# UNITED STATES PATENT AND TRADEMARK OFFICE

APPLICATION NO.	FILING DATE	FIRST NAMED INVENTOR	ATTORNEY DOCKET NO.	CONFIRMATION NO.
09/806,304	03/29/2001	Alain Brochez	BROC3001/JEK	6723

## Office Action Summary

### **DETAILED ACTION**

*Fig.2*

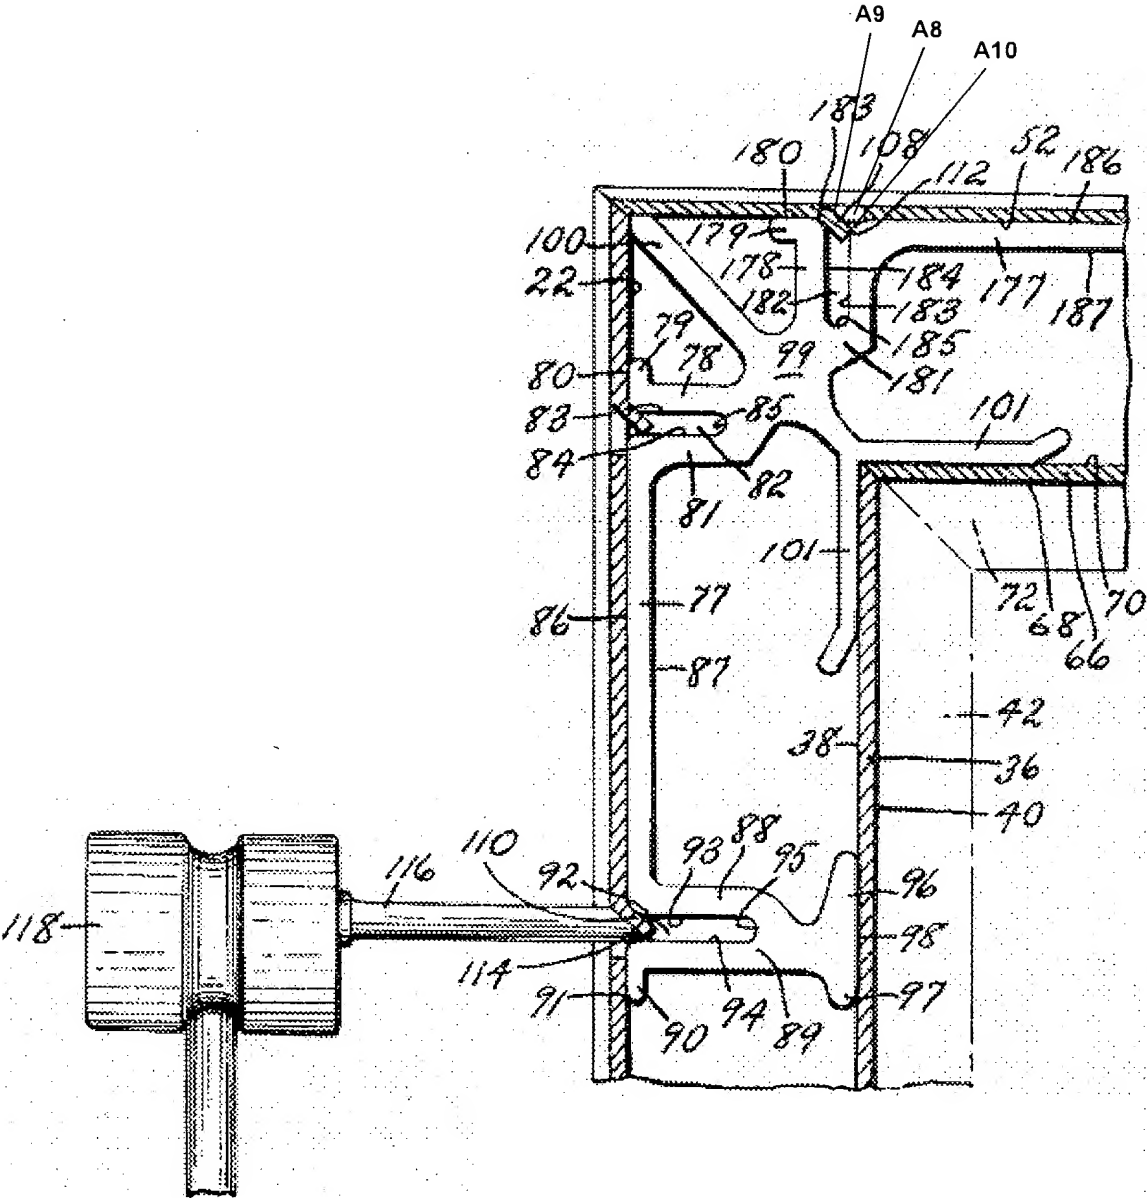
Regarding claim 33, Ekstein discloses, in Figure 2 and 3, a corner joint includes at least one corner piece **16** having two insert parts **74,75** joined at connecting ends **181** and positioned relative to one another at a predetermined angle. The corner piece **16** is provided with locking means **108** comprising lip projections **108**. The insert parts **74,75** each include at least one notch **A8** and a shape of a predominantly right-angle triangle **96**. The notch **A8** of each of the insert parts **74,75** comprises a triangular shape defined by one side **A9**, against which one of the lip projections **108** is positioned, is longer than another side **A10** over which a free end of the one of the lip projections **108** is pressed in. The lip projections **108** include a contact surface **112** disposed at one end thereof. The insert parts **74,75** includes at least one locking element **102** defining a contact surface configured geometrically. The locking element **102** has at least one characteristic, i.e., the at least one locking element **102** is only connected to the corner piece **16** at a base portion **178**.
